PROJECT NAME: WEATHERSFIELD  
PROJECT NUMBER: CMG PARK(17)S

TYPICAL SECTIONS

FILE NAME: z99k014sht\_lay.dgn  
 PROJECT LEADER: Wayne L. Davis  
 DESIGNED BY: AGB  
 PLOT DATE: 8/20/2008  
 DRAWN BY: AGB  
 CHECKED BY: SJG  
**PLAN SHEET**  
 SHEET 9 OF 36

FILE NAME: z99k014sht\_lay.dgn  
PROJECT LEADER: Wayne L. Davis  
DESIGNED BY: AGB  
MISCELLANEOUS DETAILS SHEET

FILE NAME: z99k014sht\_lay.dgn  
PROJECT LEADER: Wayne L. Davis  
DESIGNED BY: LFC  
LIGHTING AND ELECTRICAL PLAN SHEET SHEET 19 OF 36

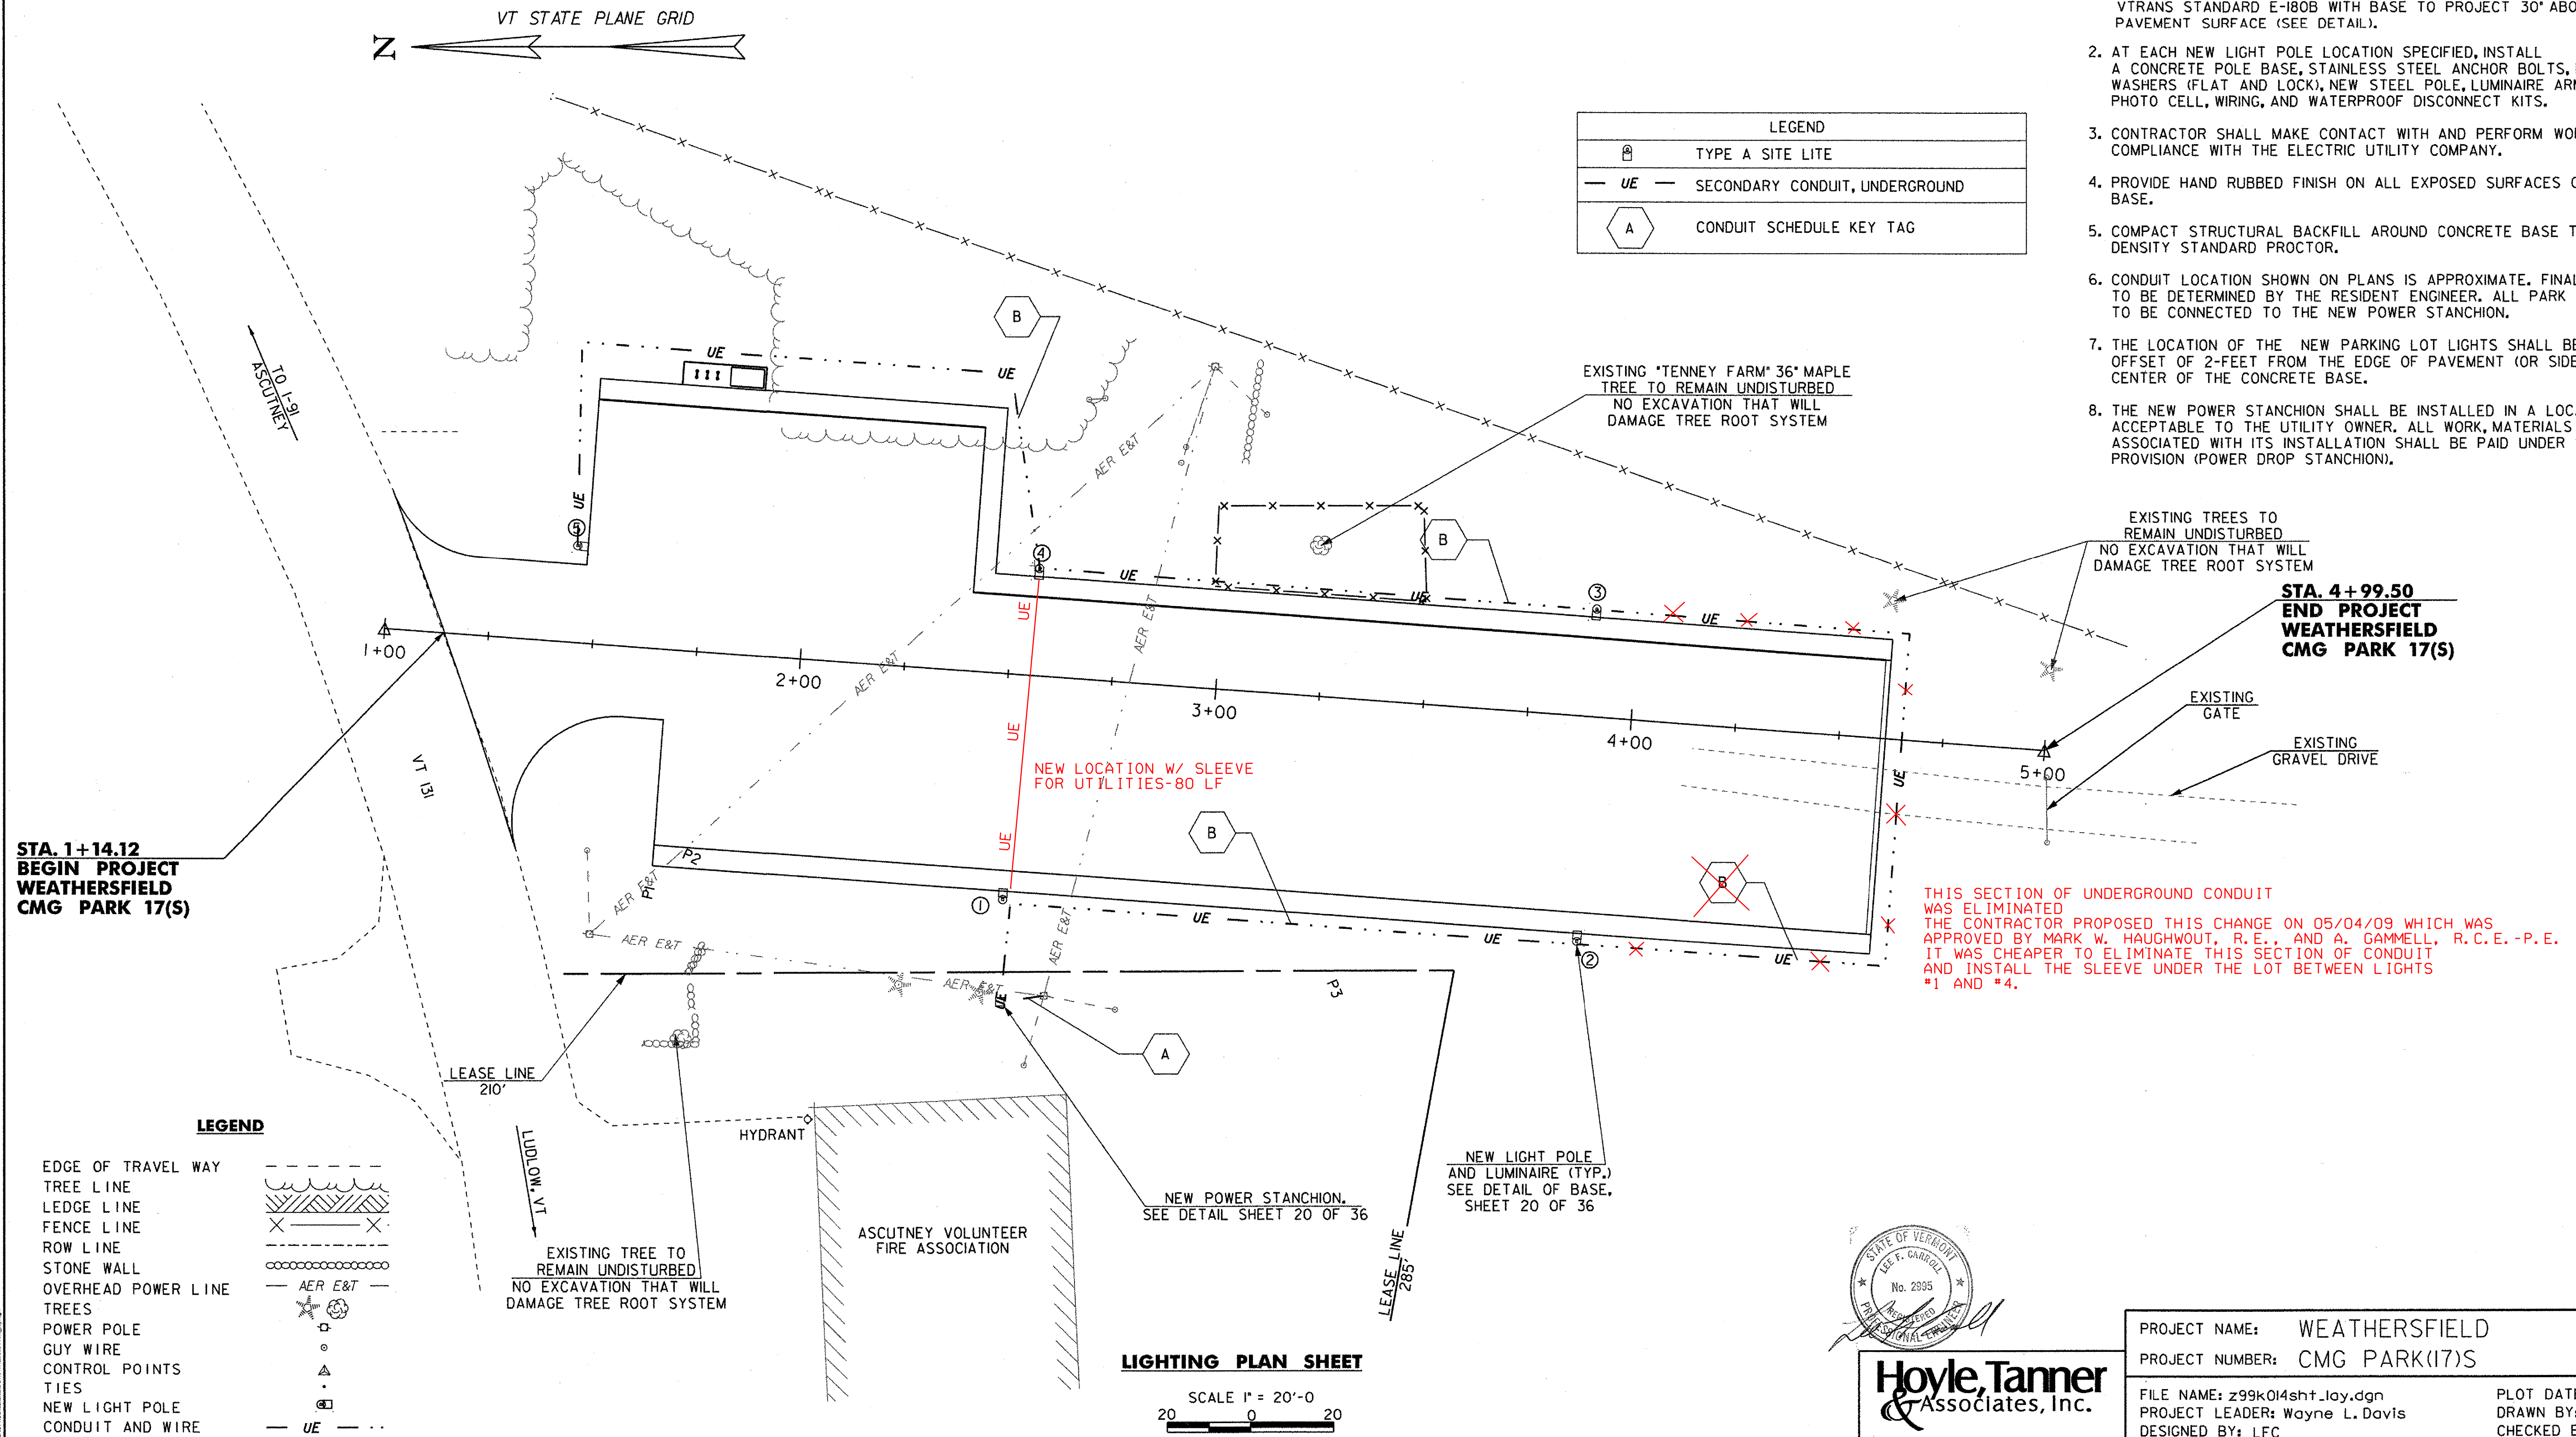
ITEM 900.520 S.A. (679.45 LIGHT POLE (MOD)) WAS ADDED TO THE CONTRACT REPLACING ITEM 679.45 LIGHT POLE SEE C.O. #5, DATED 08/06/09
